Title:	Proposed Great Wolf Lodge, Chesterton, Bicester	Date Approved:	August 2022
Discipline:	Civils	Author:	Paul Davis
Note Ref:	2180501-EWP-XX-ZZ-TN-C-0006

This technical note has been prepared in response to the Lead Local Flood Authority (LLFA) comments on Condition 16 of application number 22/01815/DISC dated 19.07.22.

Catchment plan and updated below ground drainage drawings

Drawing title
Surface Water Catchment Plan

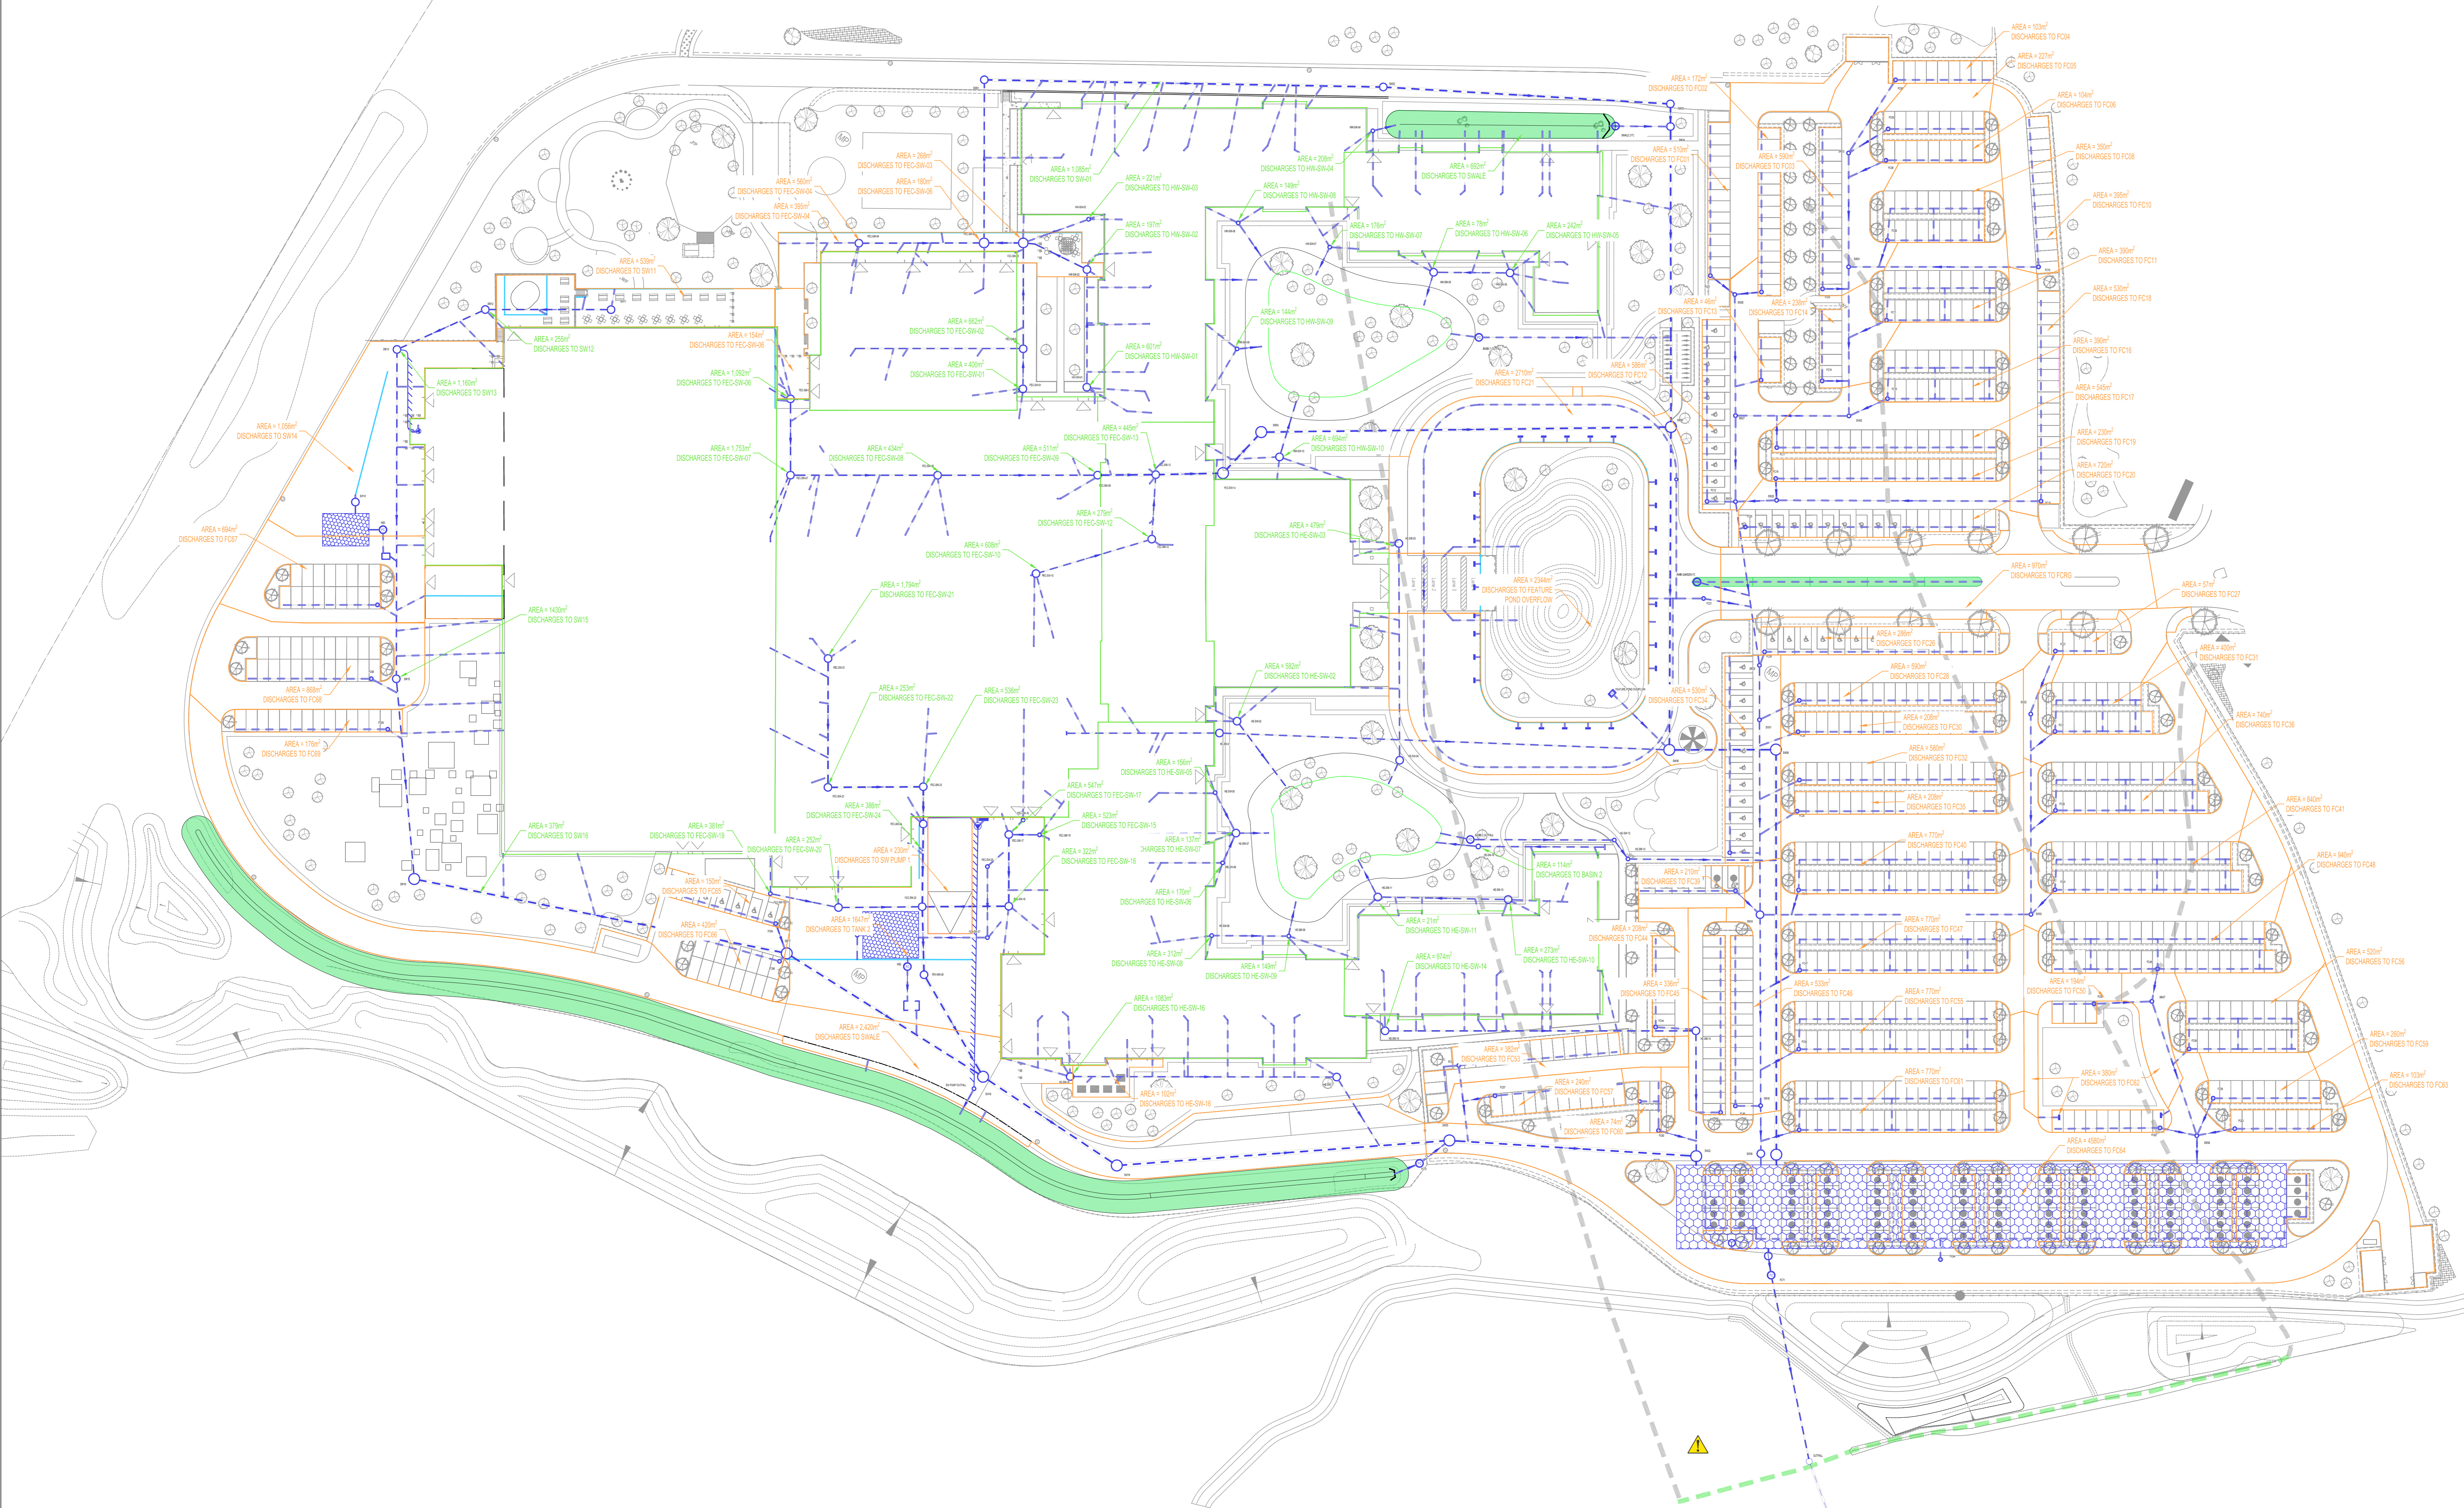
b) Provide surface water catchment plan, clearly showing the extent of the area and stating the area. Ensure all SuDS features are labelled on the drainage strategy drawing and read in line with the calculations.

A catchment plan has been prepared, in addition pipe numbers have been added to the below ground drainage drawings, these drawings are presented in **Appendix A** of this report.
